SUBDIVISION REVIEW SHEET

CASE NO.: C8J-2008.0168.01.1A

SUBDIVISION NAME: Entrada Phase 1 A Small Lot Subdivision

CITY OF AUSTIN – TRAVIS COUNTY – SINGLE SUBDIVISION OFFICE
SUBDIVISION APPLICATION – MASTER COMMENT REPORT

SHEET NO. 2 OF 7 [®]

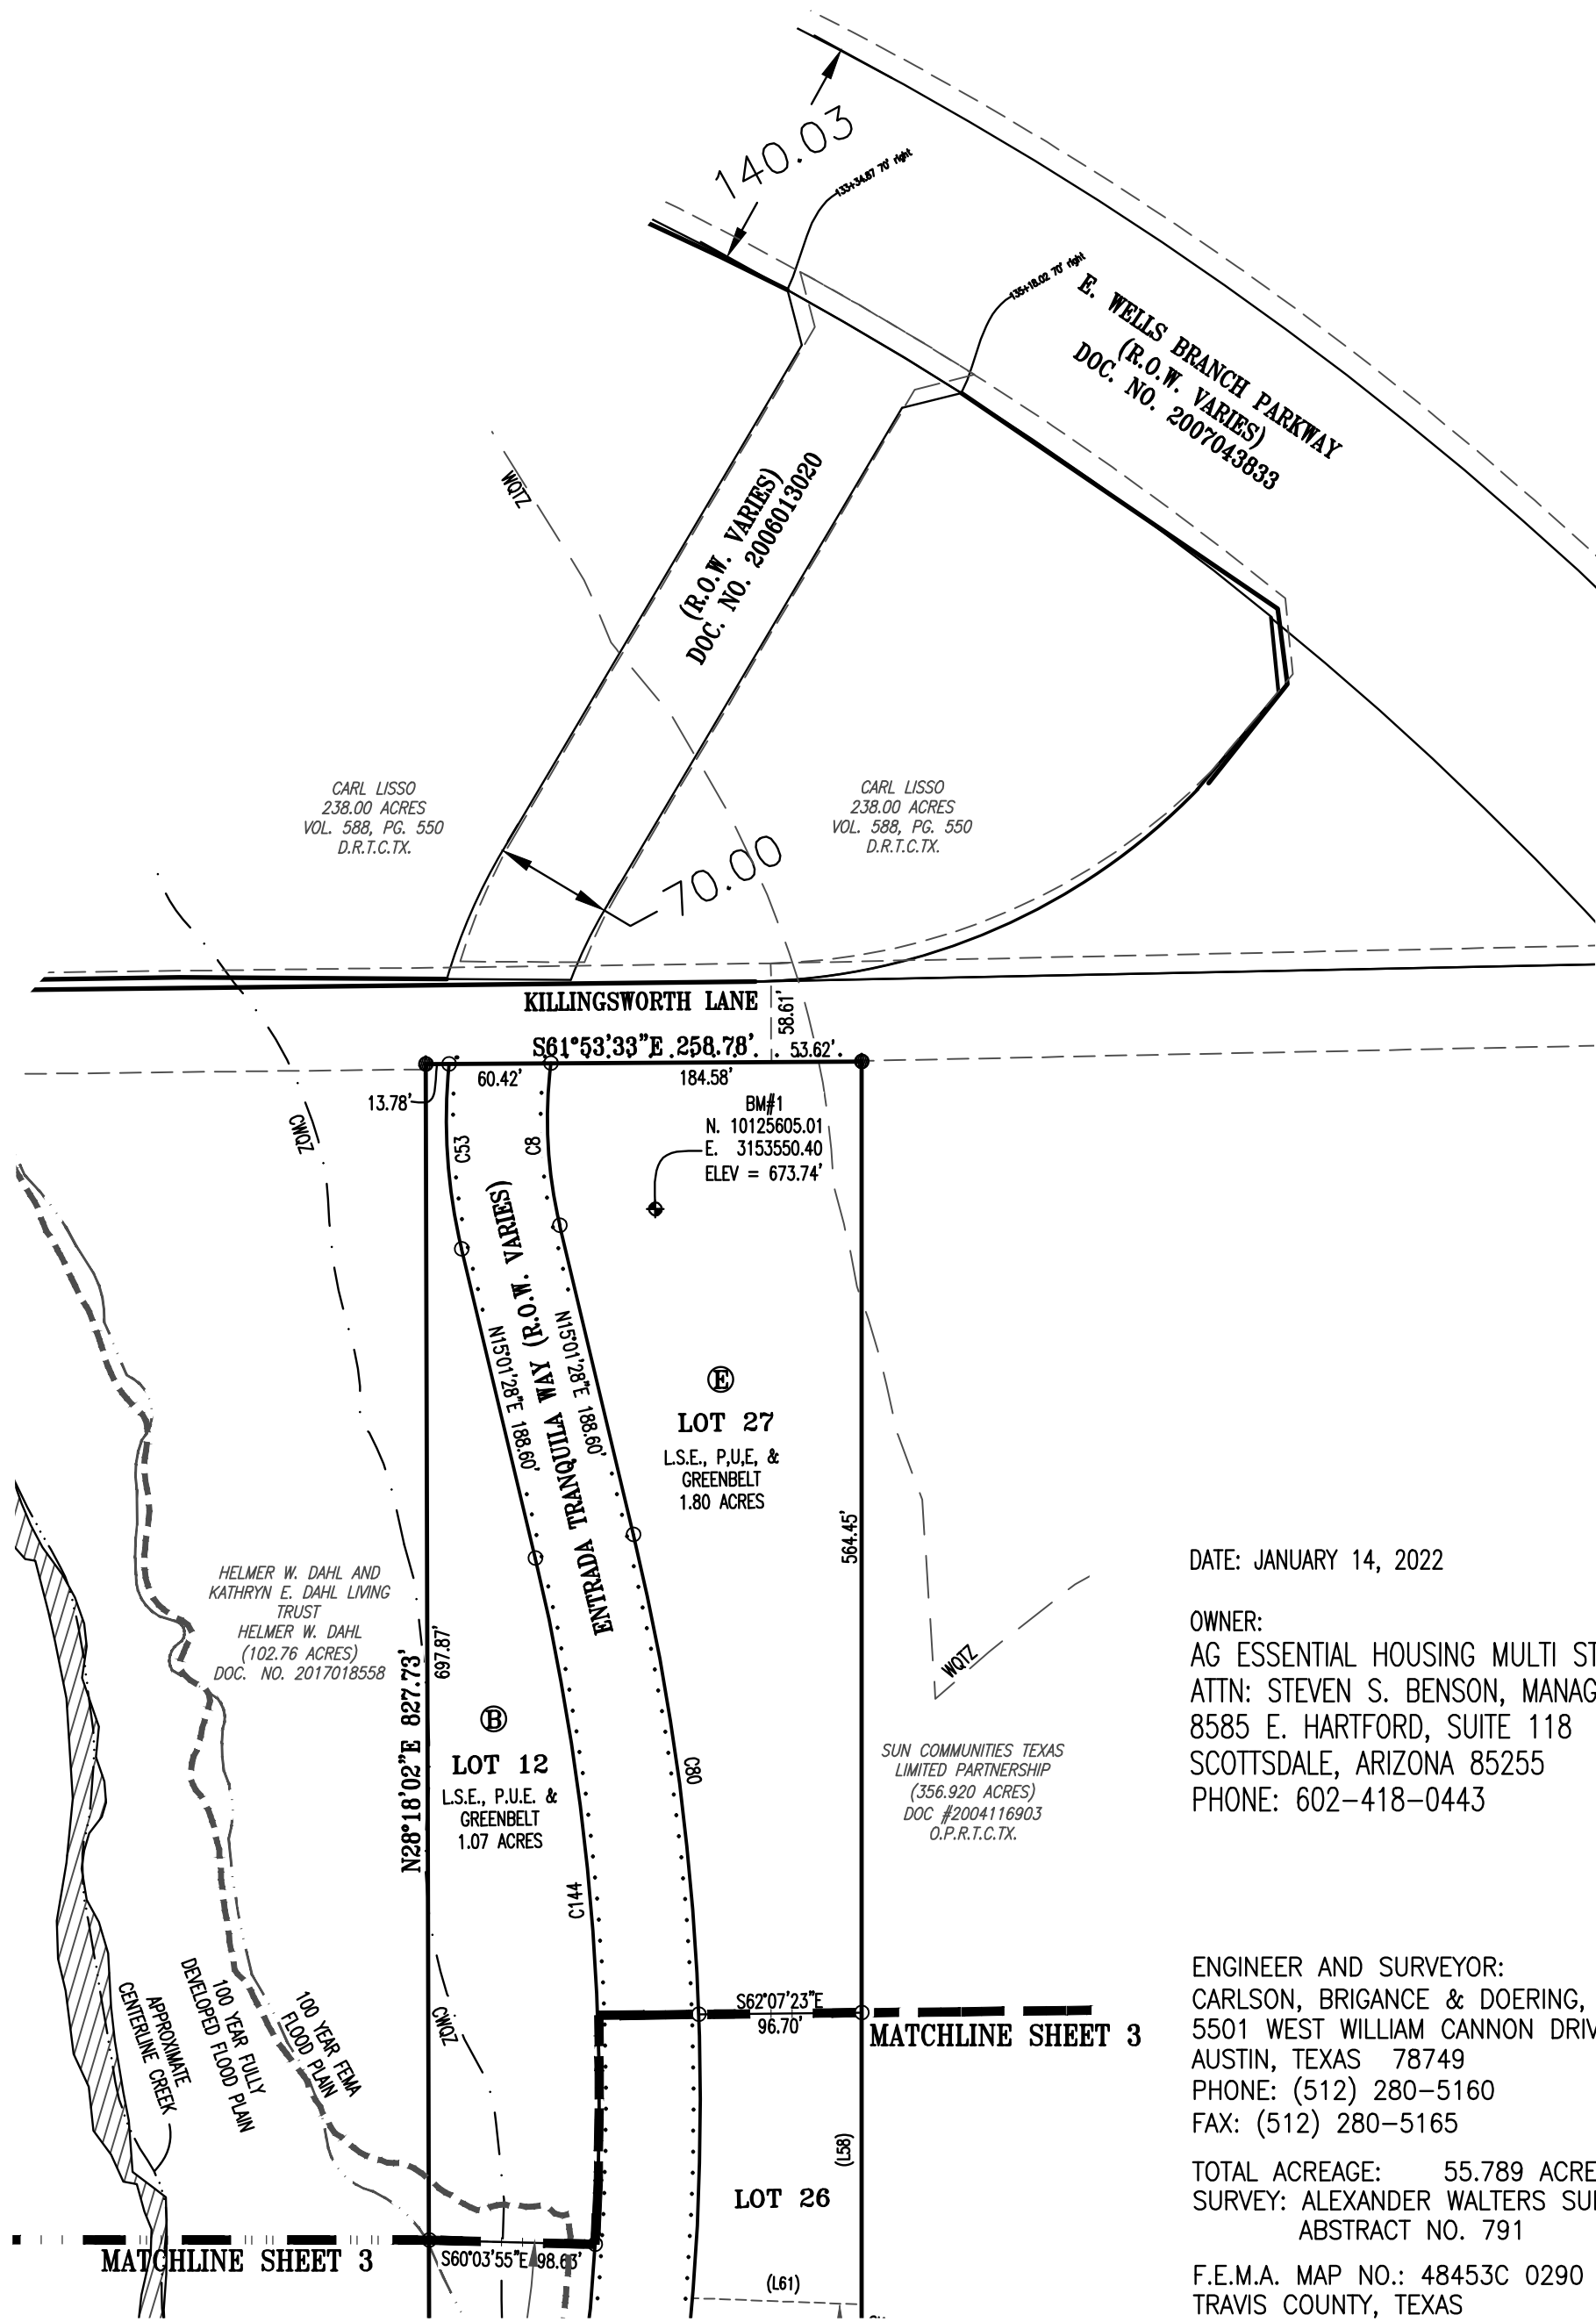
SHEET 2

4. Show the location of the ROW change from 70' wide to 60' wide.

5. In the street widths table, provide the total acres of ROW.

SHEET NO. 3 OF 7

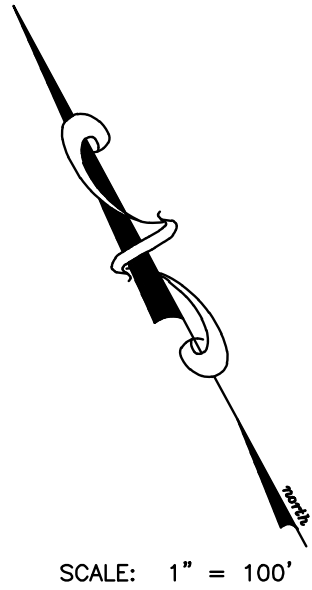
MATCHLINE
SHEET 4

SHEET NO. 4 OF 7

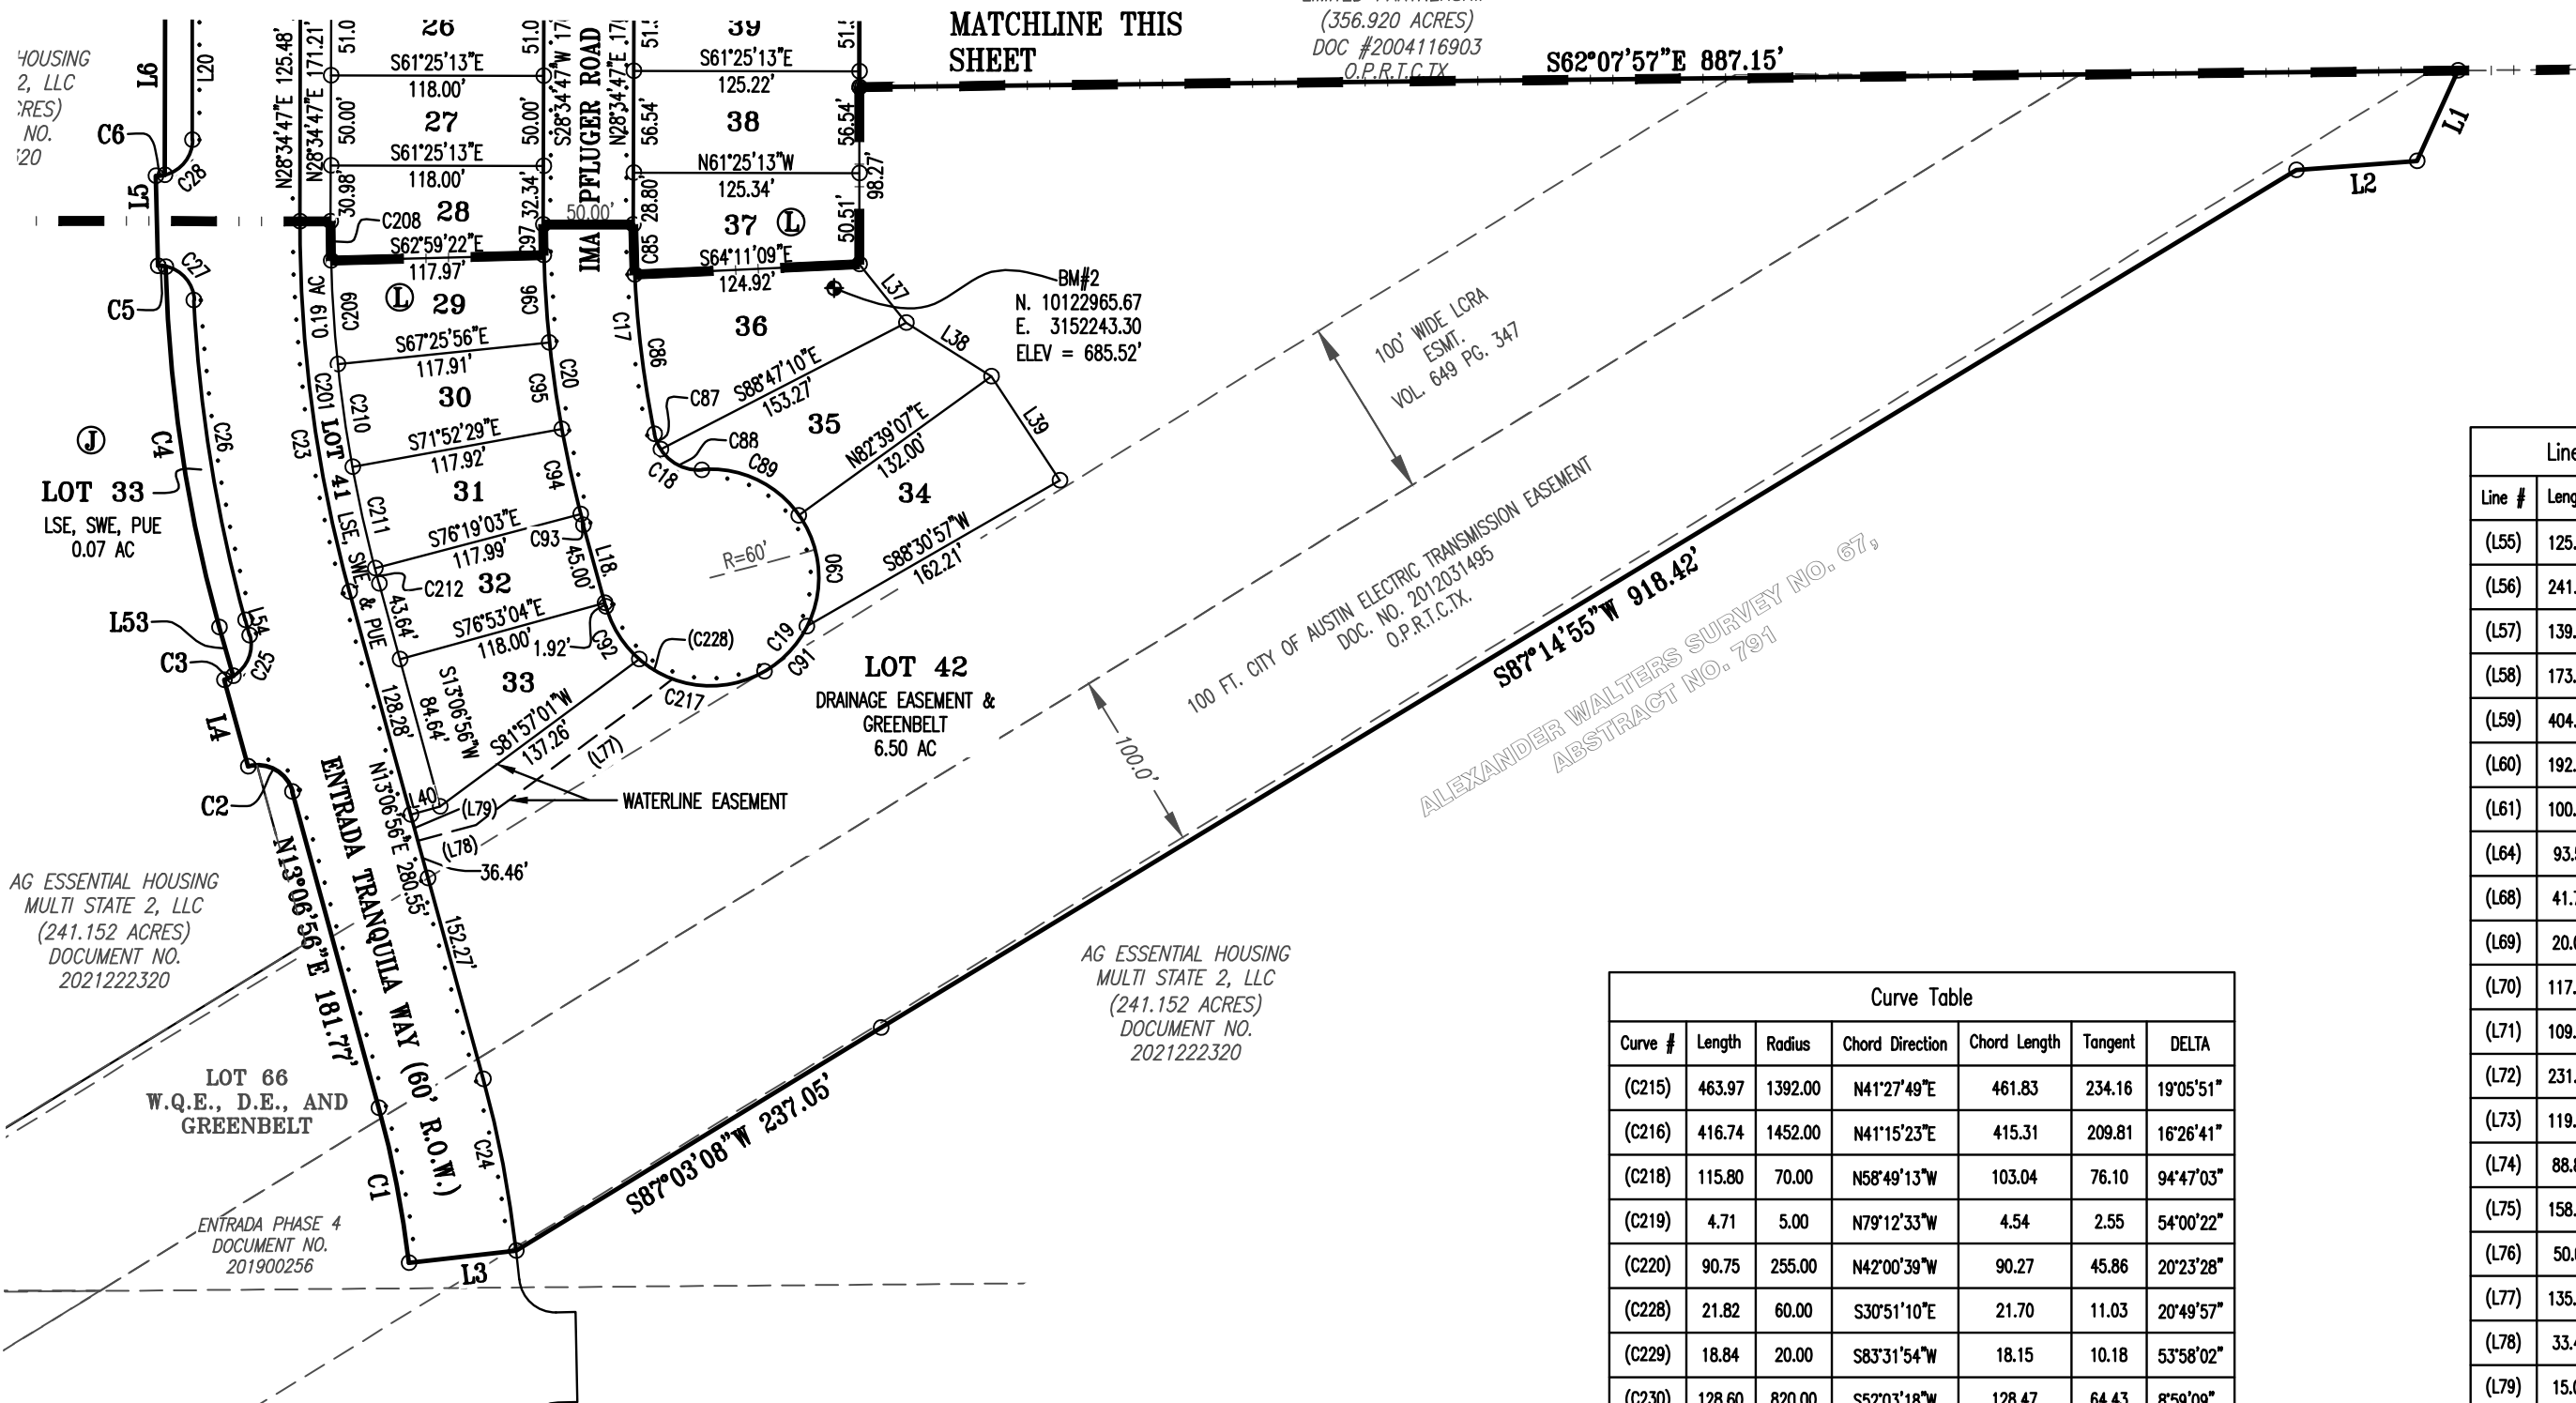
SHEET 4

6. There is no listing on sheet 2 under the summary of lots for Drainage Easement and Greenbelt.
